MFN 09-788, Rev. 1

Subject: Revised Response to Portion of NRC Request for Additional Information Letter No. 391 Related to Design Control Document (DCD) Revision 6 – Fuel Racks - RAI Number 9.1-145

Fuel Racks

RAI Number 9.1-145

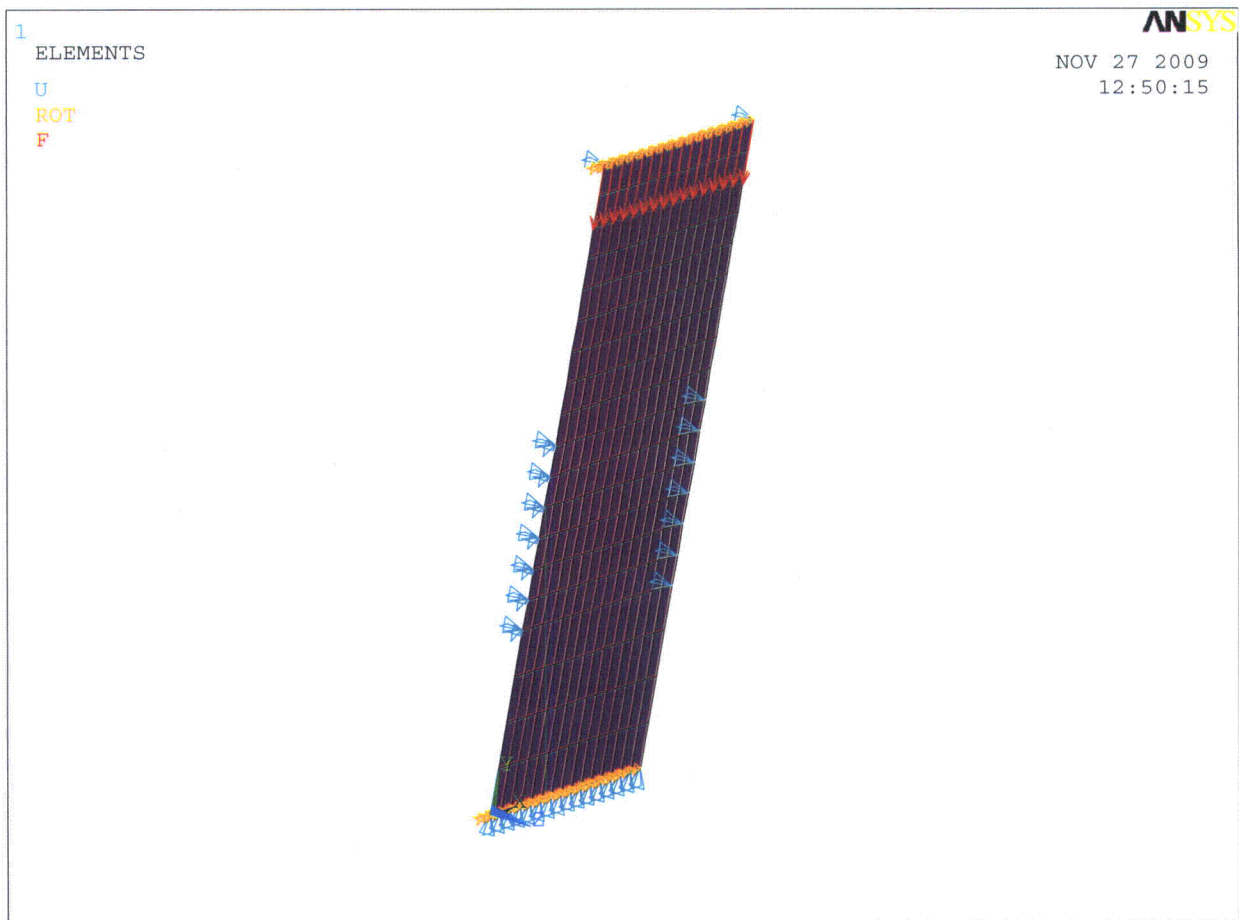
Section 1.4.7 of NEDE-33373P, rev. 3 provides that the stress limits for Service Level D were based on F-1332 of Appendix F to ASME B&PV Code, Section III, Division I, and provides the stress limits for various stress conditions except for compressions. Requirements for compressive stresses are provided under F-1332.5 which then refers to the rules of F-1331.5 (a). Without an evaluation of the racks subject to compressive stresses in accordance with the rules of F-1331.5 (a), the staff considers the applicant's Service Level D analysis is incomplete.

The staff requests that the applicant provide an evaluation of rack plates subjected to compressive loads induced during the Service Level D load combination against buckling limits per F-1331.5 (a) of Appendix F to ASME B&PV Code, Section III, Division I.

For lateral 10 mm plate, the typical unbraced portion of lateral plates can be seen below.

The typical unbraced length is about $712/4 = 178$ mm.

Therefore, the buckling calculation is performed for a 10 mm plate with a span of 178 mm.
